EAST TOWN CROSSING
CLUBHOUSE SWIMMING POOL & SPA
3002 E Pioneer Way PUYALLUP WA 98372
P/N: 0420264053

DRAWN BY:	BL / CM
CHECKED BY:	BL
DATE:	25.11.03
TITLE:	SITE PLAN
PROJECT #:	2016
SHEET:	AS1.0

AGENCY REVIEW - REVISION No.1 | 25.11.03

1 SITE PLAN
SCALE: 1" = 30'

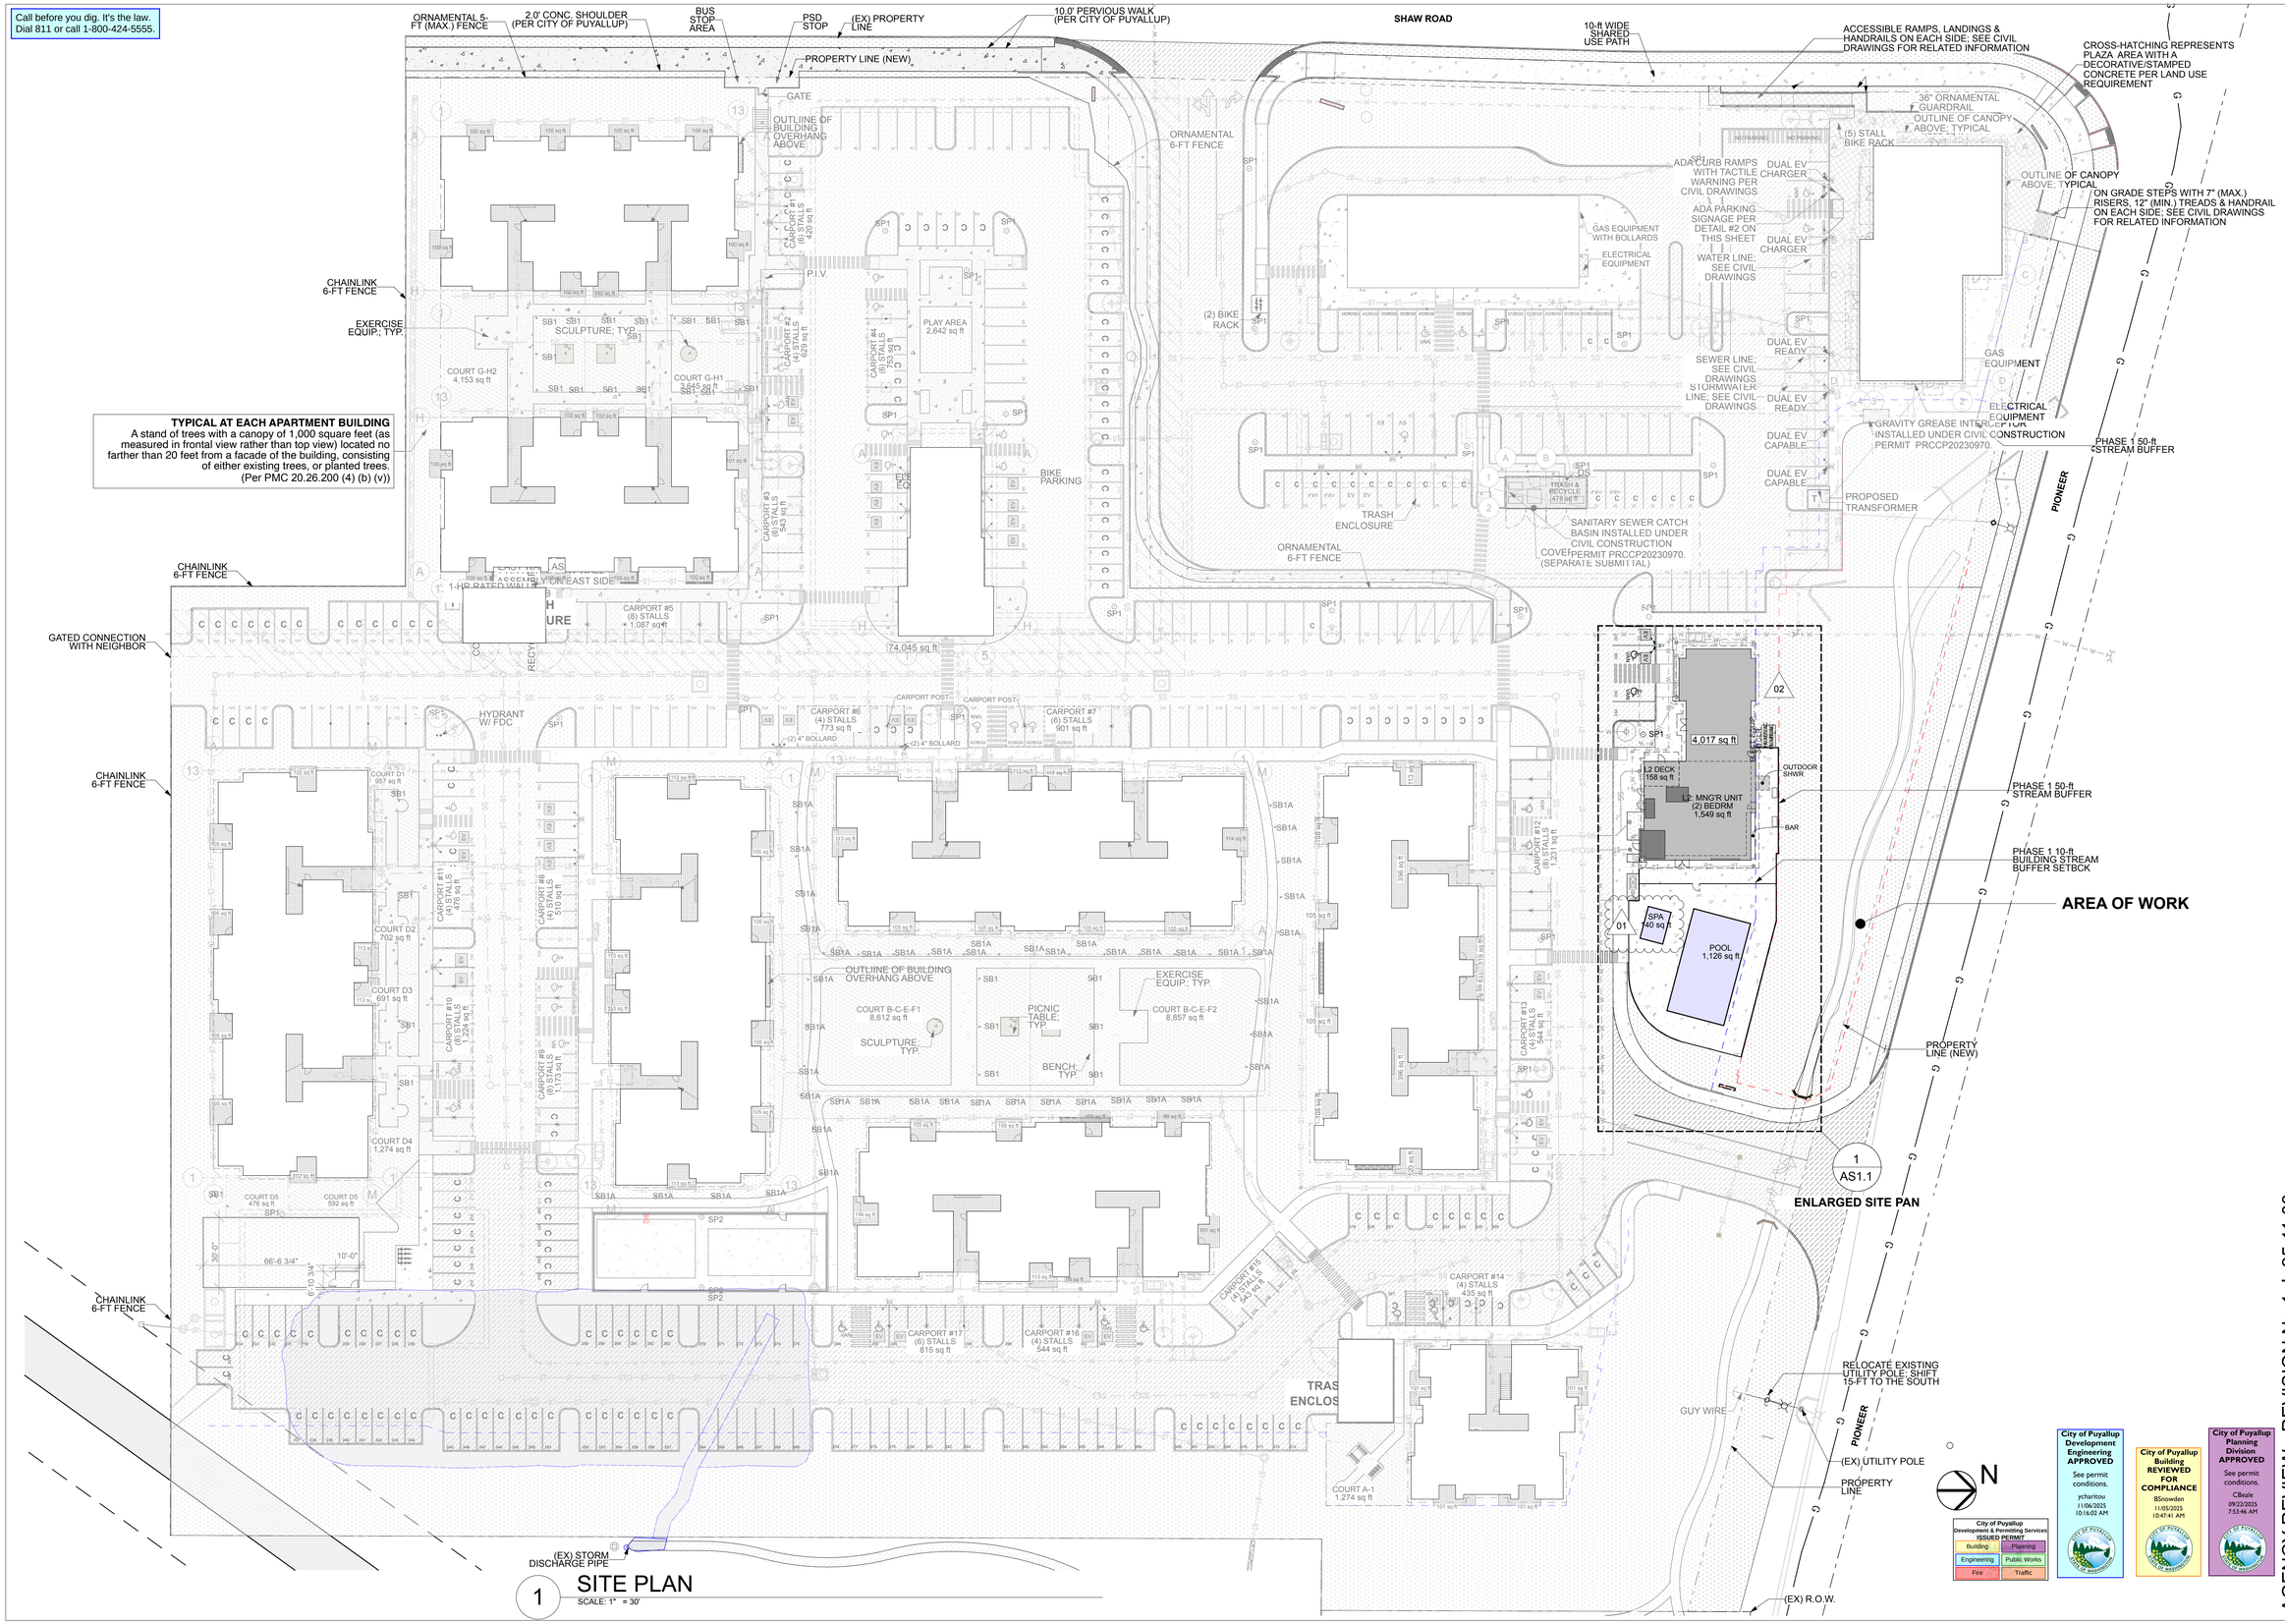
According to the correction letter dated November 3, 2025, the architect is electing to have the pool contractor field fit the pool piping plan depicted in the construction plan set instead of depicting the piping on this site plan to identify any possible conflicts with existing utilities installed under civil construction permit PRCCP20240808. The contractor shall proceed at his own risk. Any conflicts shall be addressed in the field at the expense of the contractor. The contractor shall locate all utilities prior to installing pool piping. The contractor must pass the City Engineering utility inspection prior to backfilling any pool piping to verify utility separations are satisfactory.

The contractor shall locate the existing 6" CPEP storm drain line installed under civil construction permit PRCCP20240808 prior to installing the perimeter fence footings. If necessary, the contractor shall relocate the storm drain line or protect it in place to avoid damaging it with the new footings.

An approved reduced pressure backflow assembly (RPBA) device is required to be installed on the domestic water service to the clubhouse per City Standard Detail 03.04.02 since the potable water service will have a direct connection to the pool. As noted, the RPBA shall be installed under civil construction permit PRCCP20240808. The PRPO20251217 pool building permit cannot be completed until the RPBA passes inspection and testing under civil construction PRCCP20240808.

[2021 Washington Swimming Pool and Spa Code, Section 305.1.1]
Construction Fencing Required
The construction sites for in-ground swimming pools and spas shall be provided with construction fencing to surround the site from the time that any excavation occurs up to the time that the permanent barrier is completed. The fencing shall be not less than 4 feet (1219 mm) in height.
